Access Compliance Report

Public Rights-of-Way

Intersection ID: 12925	Main Street: S_CHURCH_ST	Cross Street: W_CARSON_BV	Location: NE
ADA ID: 6622F9E85CA0	Ramp Type: PerpDiag	Initial Pass/Fail: Fail	Overall Compliance: No
		Severity Score: 25

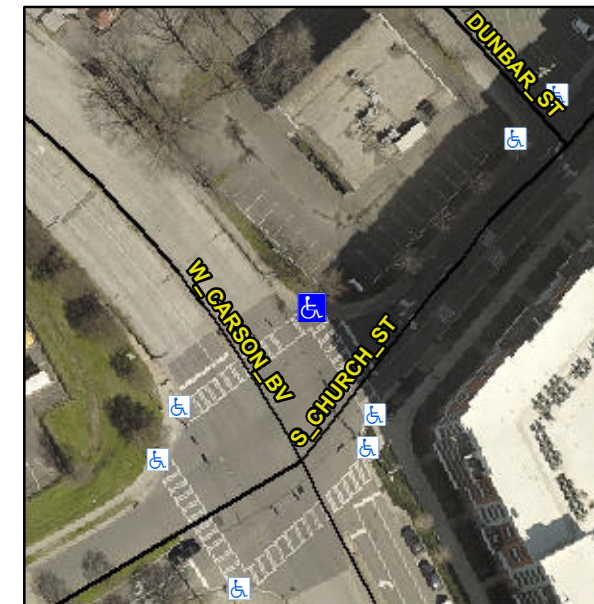
Compliance	Description	Data	Compliance	Description	Data
N/A	Ramp Length (in)	64.0	No	Ramp Slope (%)	10.1
Yes	Ramp Width (in)	48.0	No	Ramp XSlope (%)	5.3
N/A	Flare Type LT	N/A	N/A	Flare Type RT	N/A
N/A	Flare Slope LT (%)	N/A	N/A	Flare Slope RT (%)	N/A
N/A	Flare Traversable LT?	N/A	N/A	Flare Traversable RT?	N/A
N/A	Landing Length (in)	N/A	N/A	DWS Provided?	N/A
N/A	Landing Width (in)	N/A	N/A	DWS Contrast?	N/A
N/A	Landing Slope (%)	N/A	N/A	DWS Length (in)	N/A
N/A	Landing X Slope (%)	N/A	N/A	DWS Full Width?	N/A
N/A	Landing Curb? (Y/N)	N/A	N/A	DWS Offset (in)	N/A
N/A	Shared Landing?	N/A			
N/A	Gutter Ponding?	N/A	N/A	Gutter Slope (%)	N/A
N/A	Gutter Lip Ht (in)	N/A	N/A	Gutter X Slope (%)	N/A
N/A	Painted X Walk1?	Yes	N/A	Painted X Walk2?	Yes
	X Walk 1 Direction	To SW		X Walk 2 Direction	To S
N/A	X Walk 1 Width (in)	113.0	N/A	X Walk 2 Width (in)	114.0
	X Walk 1 Slope (%)	0.9		X Walk 2 Slope (%)	4.3
	X Walk 1 X Slope (%)	4.7		X Walk 2 X Slope (%)	1.9

N/A	Ramp inside XWalk1?	Yes	N/A	Ramp inside XWalk2?	Yes
	Road Slope (%)	5.4	N/A	Clear Space?	N/A
	Road X Slope (%)	3.9	N/A	Clear Space to XWalk (in)	N/A
N/A	Any Obstructions?	N/A	N/A	Storm Grate/Utility Hazard?	N/A
	Obstruction Type			Storm Grate/Utility Type	
		N/A			N/A
		Yes		Surface Condition? (G/P)	Good

Remove & Replace Curb Ramp With Two New Directional Ramps or Equivalent.

R304.2.2, R304.5.3
